V3_Drainage Letter_COMMENTS.pdf Markup Summary

DRAINAGE LETTER REPORT

**FALCON BAPTIST CHURCH
11095 EGGAR DRIVE, PEYTON, CO 80831
LOT 1, HADDEN HEIGHTS**

**JPS Project No. 012502
PCD File No.: PPR2516**

DETENTION BASIN OUTLET STRUCTURE DESIGN

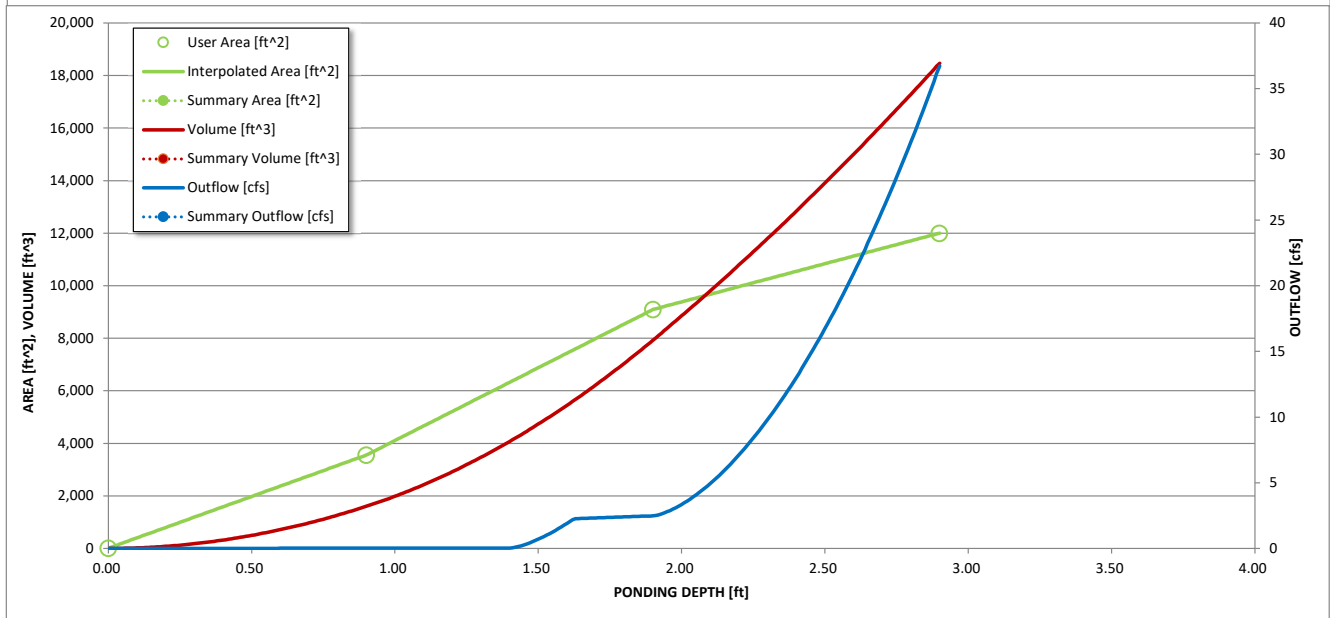
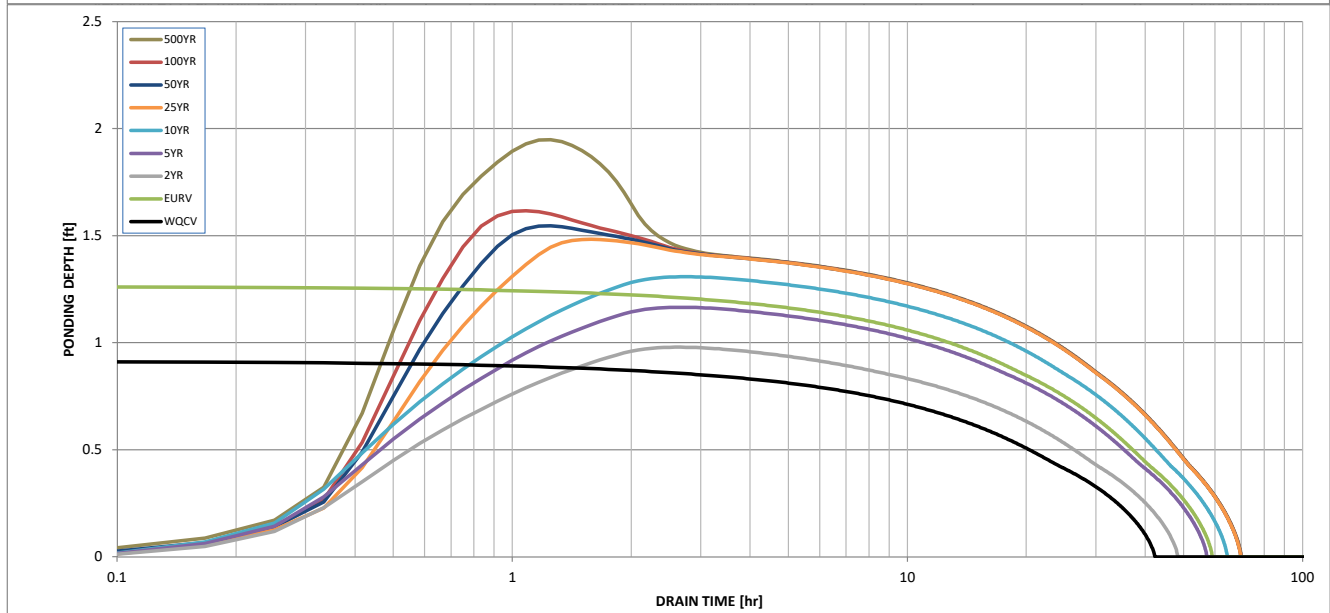
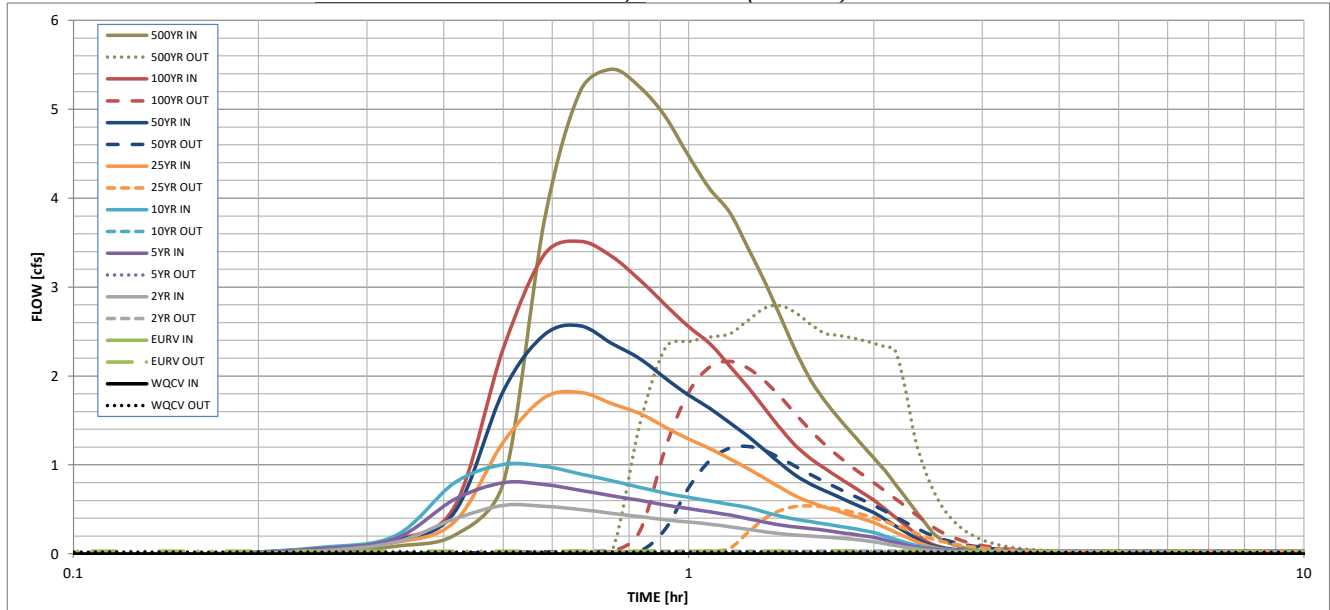
We can't really review any of these calcs without construction plans and details to compare the calcs to. Please provide CDs for the pond.

EXISTING CONDITIONS
DRAINAGE PLAN

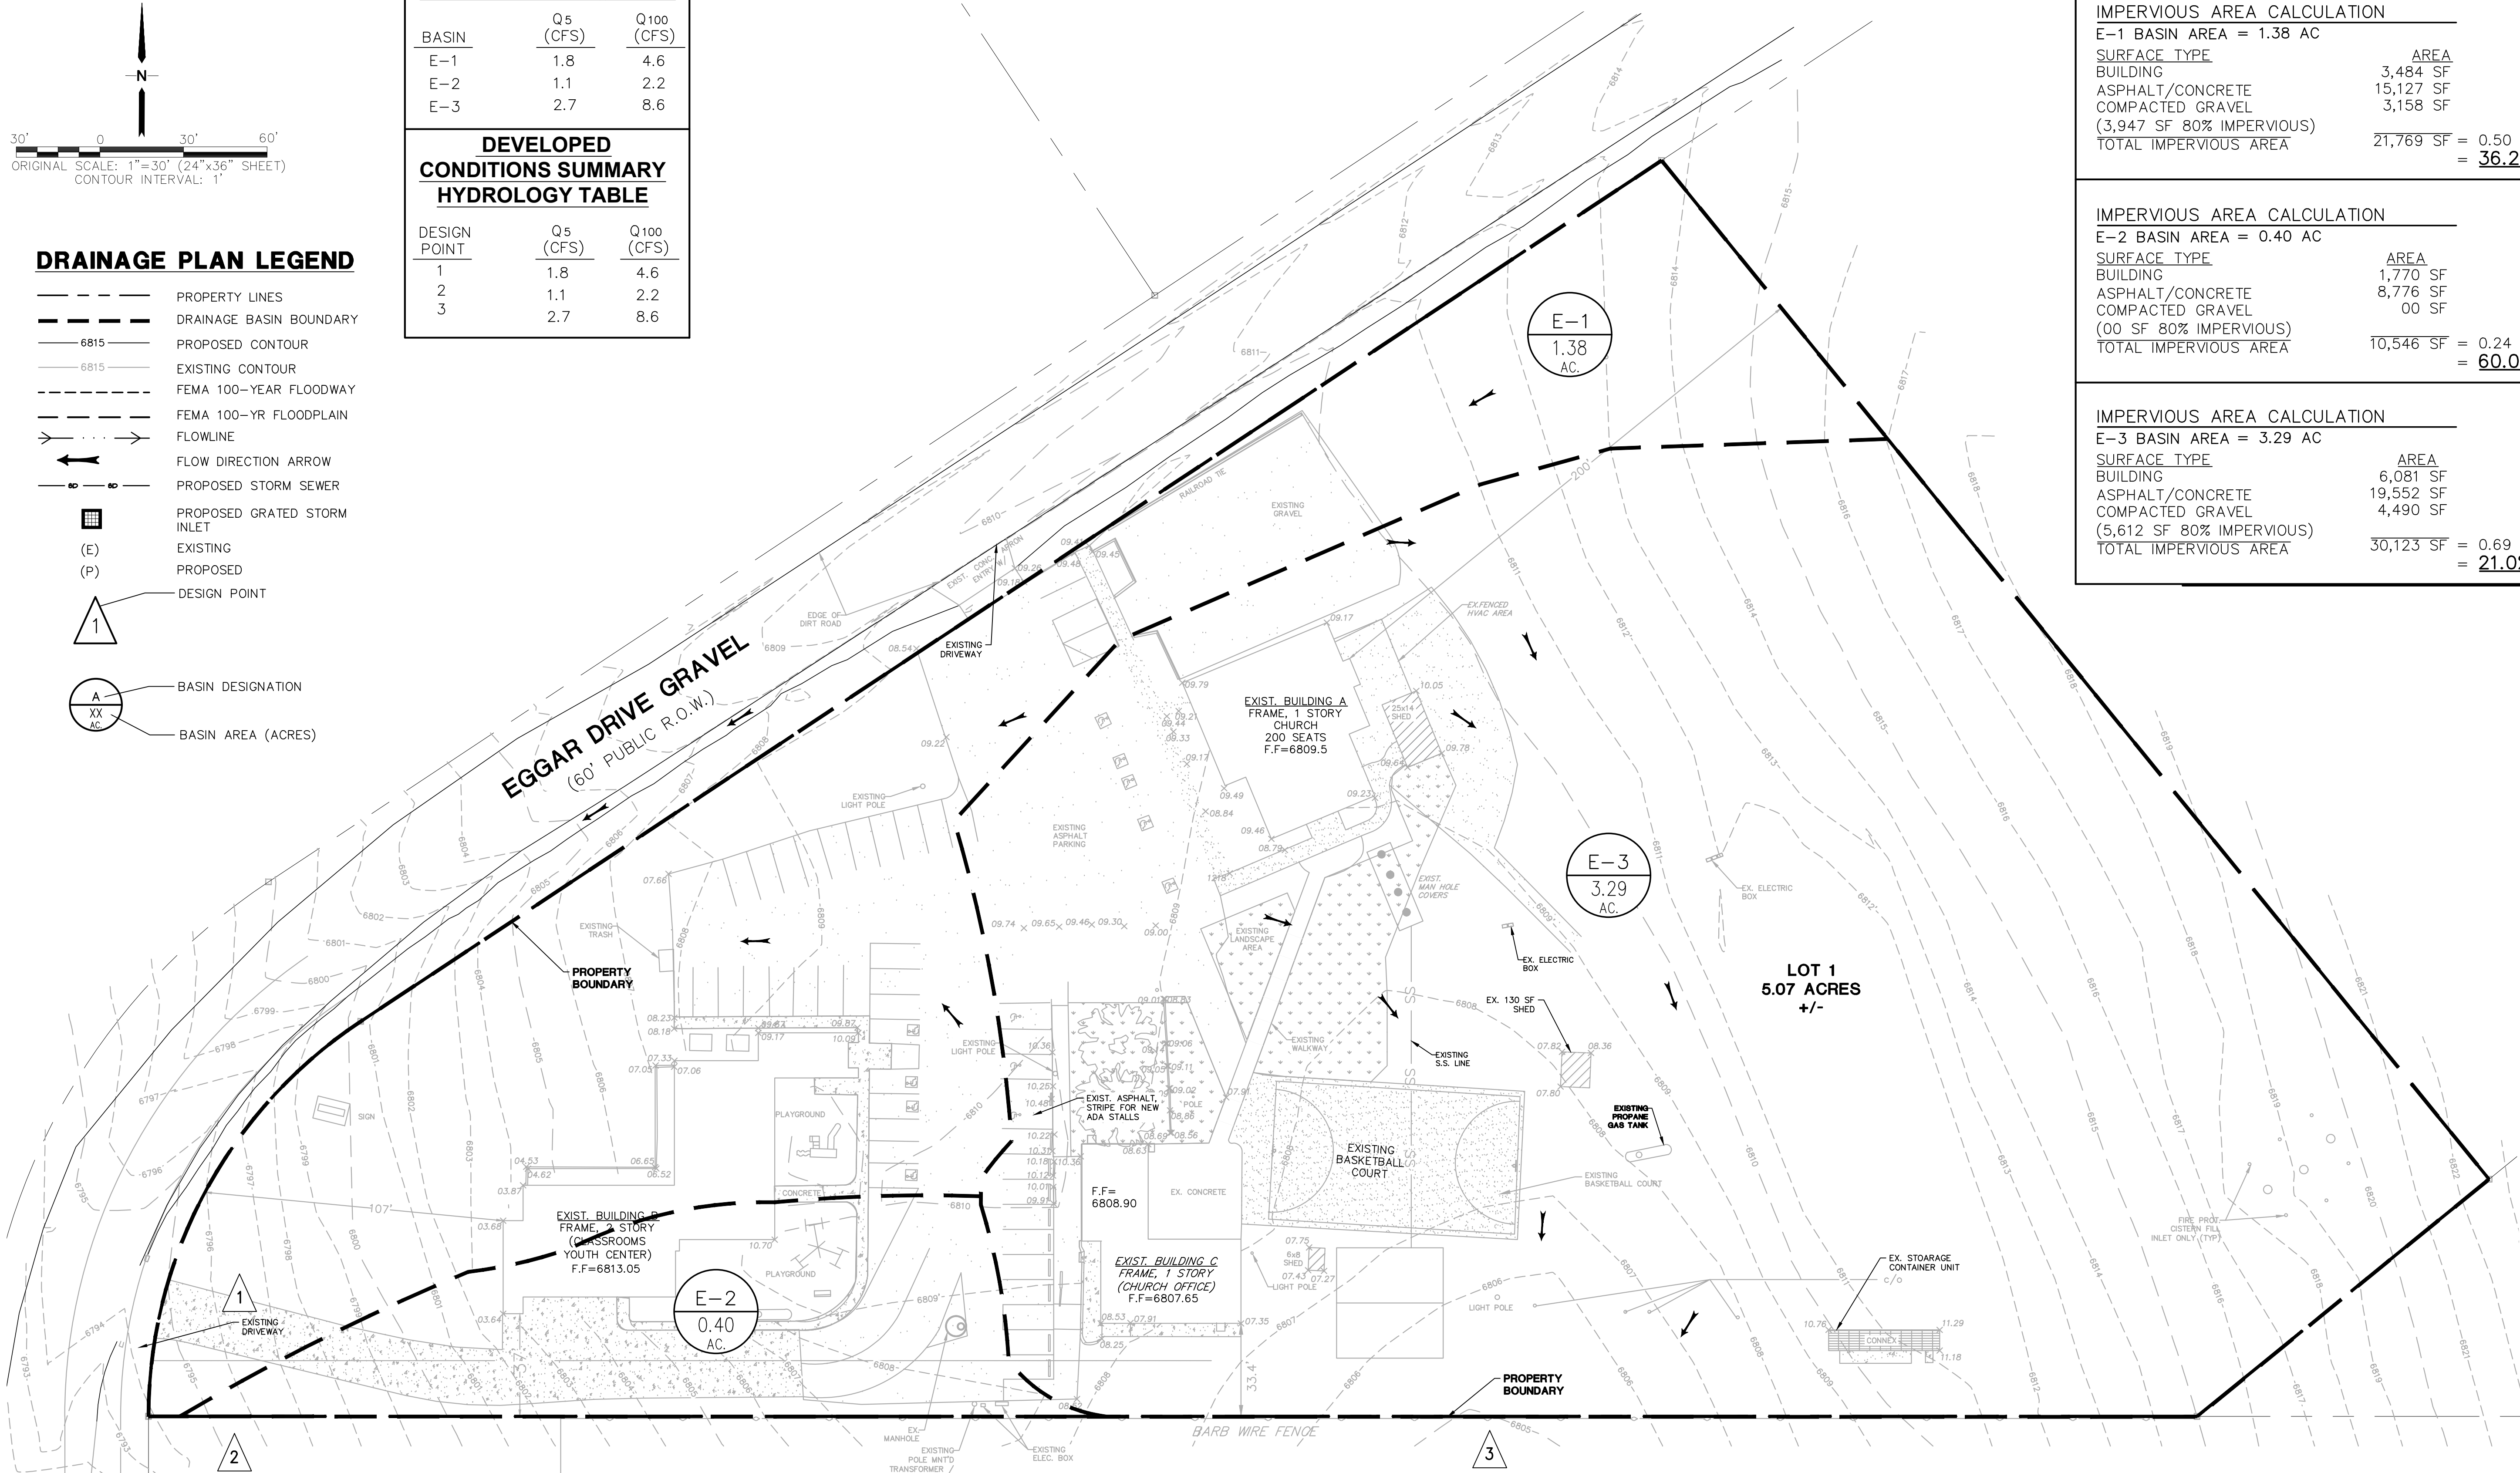
Previous unresolved comment:
please quantify these post-2008 disturbances and
categorize them as excluded vs non-excluded and
discuss the applicable exclusions. The PPR07014 plans
were actually approved in 2009 and thus count towards
the post-2008 (it's post March 10, 2008 to be specific)
disturbances, even though the file number is from 2008.

Previous unresolved comment:
We need to know how much of the proposed (and post-2008) area of disturbance (not just
the impervious surfaces) is treated vs untreated and if there are any exclusions that apply
to the untreated areas. So please create a basic overview map (or modify an existing
drainage map) with color shading/hatching that shows areas tributary to each PCM (pond,
runoff reduction, etc.) and those disturbed areas that are not treated by a PCM, with the
applicable exclusion labeled (ex: 20% up to 1ac of development can be excluded per ECM
App 1.7.1.C.1 (only if using the WQCV Design Base Standard) and exclusions listed in
ECM App 1.7.1.B.#). An accompanying summary table on this map would also be very
helpful. Example provided:
